SERVICE INSTRUCTIONS 50-695-1

IDLE JET HOLDER AND MAIN WELL AIR BLEED ASSY.

PRODUCTION DESIGN CHANGE

**BOWL COVER GASKET
1978-1984 (USED WITH STAKED JETS)**

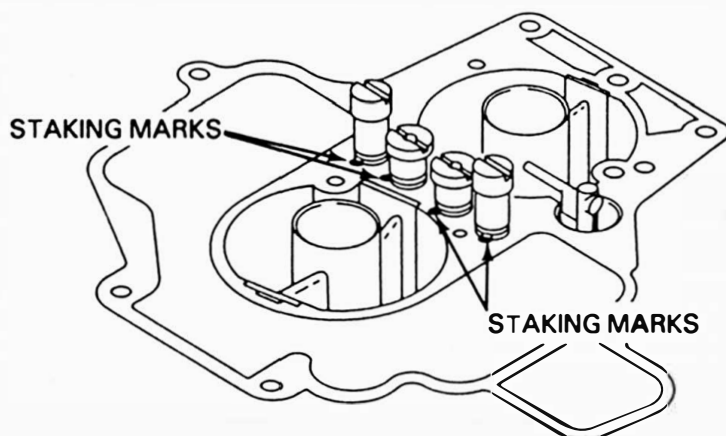
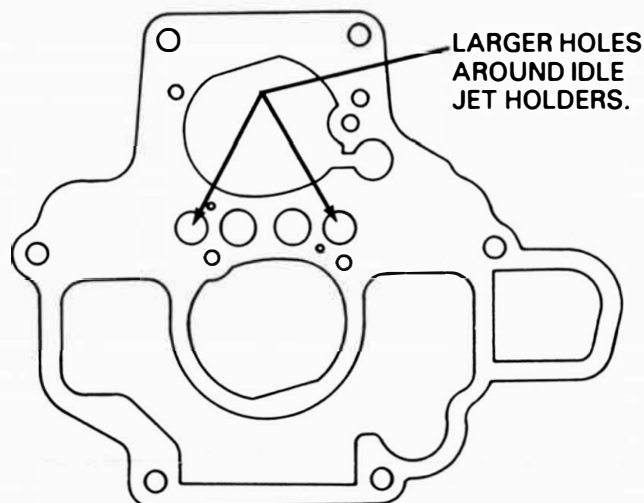
EXAMINE THE FUEL BOWL SURFACE NEAR THE HOLDERS AND JETS TO DETERMINE IF THE FUEL BOWL CASTING HAS BEEN STAKED TO PREVENT LOOSENING OF THE HOLDERS AND JETS. REFER TO THE ILLUSTRATION BELOW FOR THE LOCATION OF THE STAKING.

IF THE HOLDERS AND JETS ARE STAKED, IT IS RECOMMENDED THAT THEY NOT BE REMOVED, AS DAMAGE TO THE BRASS THREADS WILL RESULT AND REQUIRE REPLACEMENT OF THE BRASS PARTS AND REPAIRS TO THE CASTING.

**BOWL COVER GASKET
1984 & LATER (USED WITH CLIPS)**

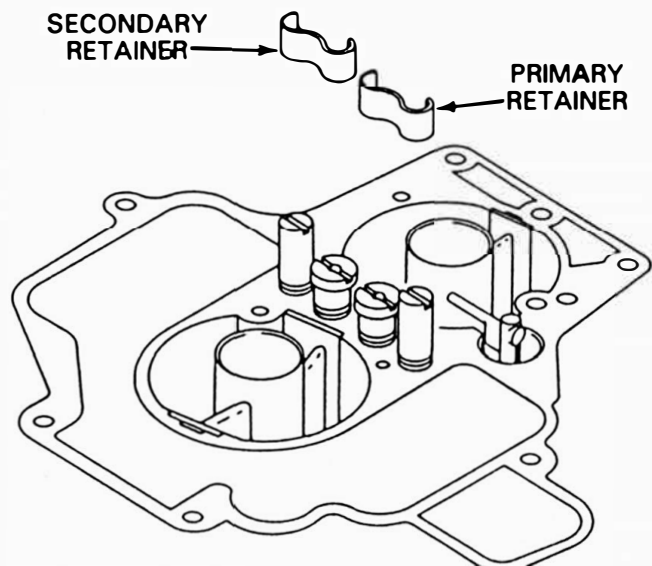
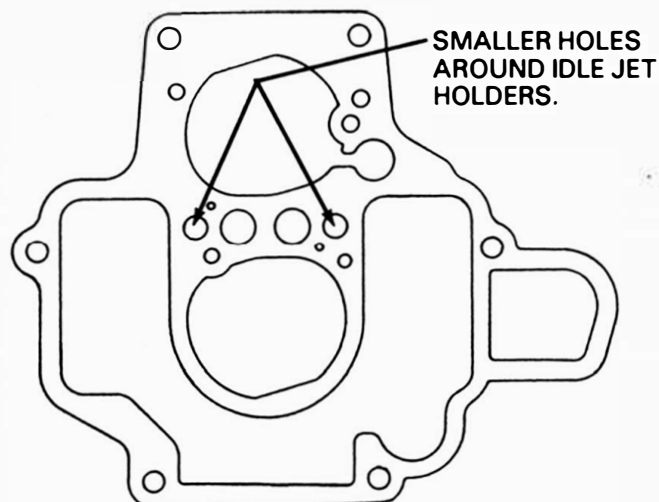
LATE PRODUCTION 1984 CARBURETORS USE RETAINER CLIPS ON THE HOLDERS AND JETS INSTEAD OF STAKING. REFER TO THE ILLUSTRATION BELOW FOR PROPER INSTALLATION OF THE RETAINER CLIPS. (NOT IN TUNE-UP KIT).

WHEN THE RETAINER CLIPS ARE USED A NEW DESIGN GASKET MUST BE INSTALLED ON THE MAIN BODY CASTING BEFORE INSTALLING THE RETAINER CLIPS. SEE ILLUSTRATION. SEE DATA TABLE FOR CORRECT FLOAT LEVEL SETTING.
